D1102312
Rev1/Serial

Shutter Control

LIGO-E1300580-V1

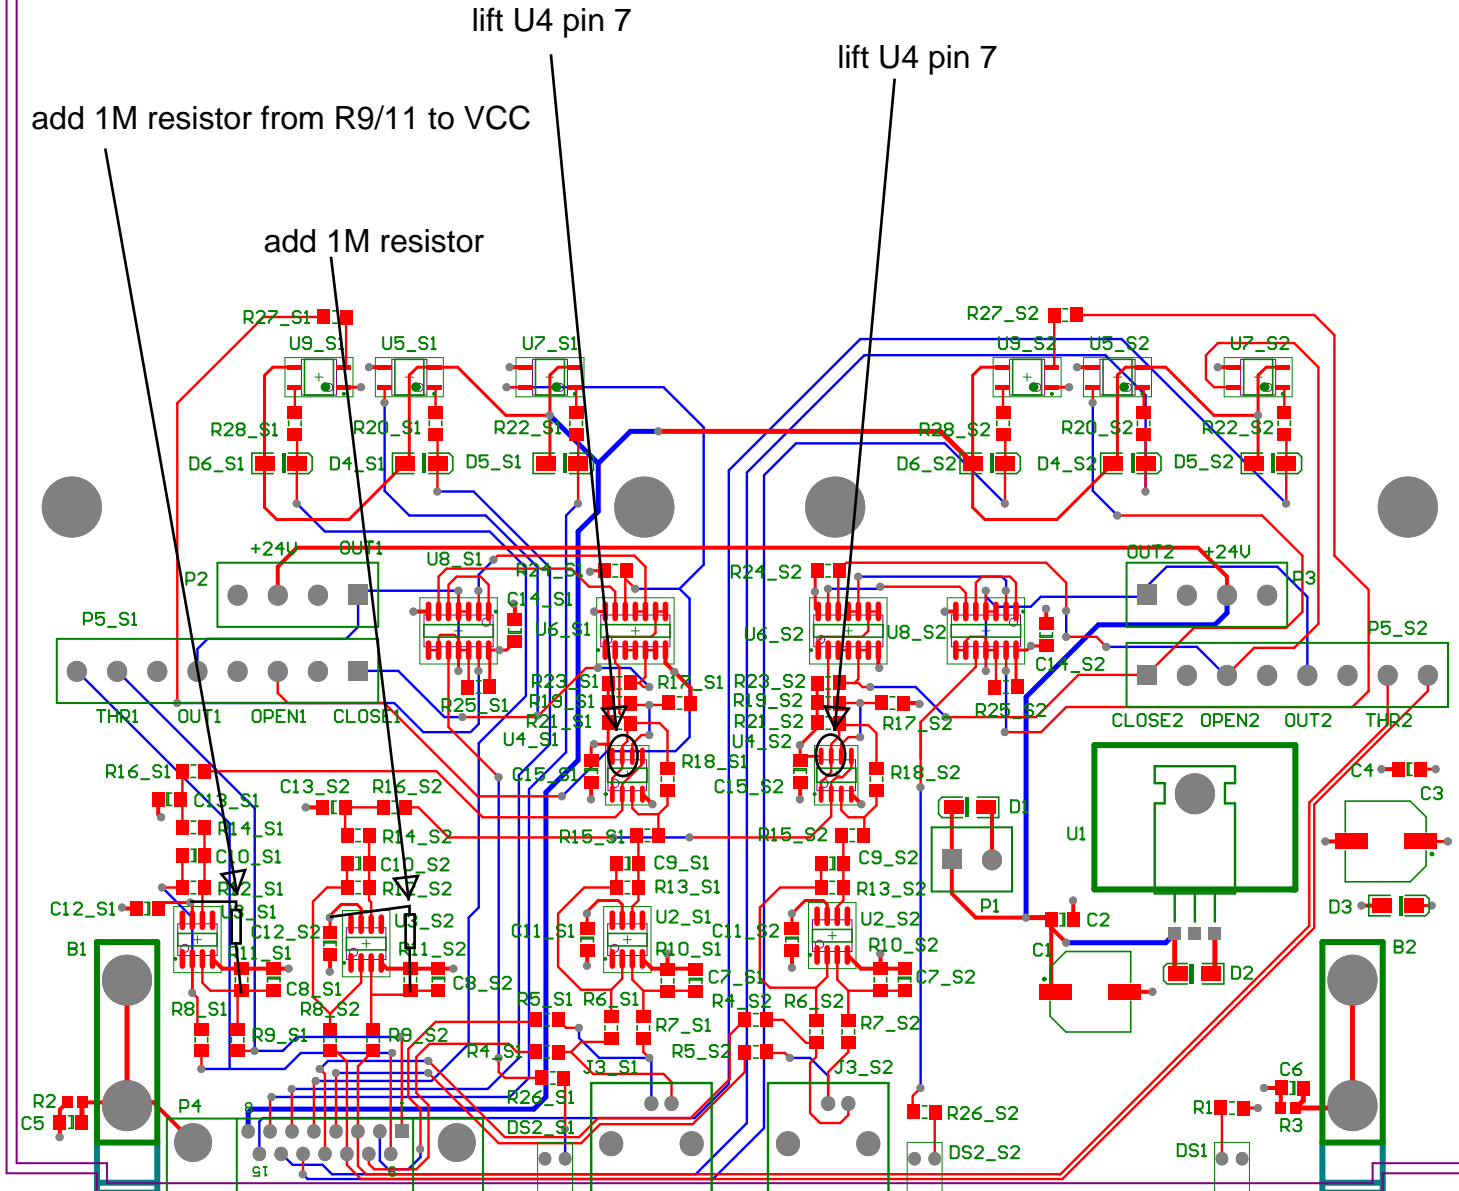
Shutter Controller Modifications:

1. Lift pin of U4 to disable the broken threshold disable feature
2. Add a 1M Ohm resistor at the threshold input to add a small positive offset to the threshold. This will allow the shutter to operate when threshold and trigger are not used and unconnected.
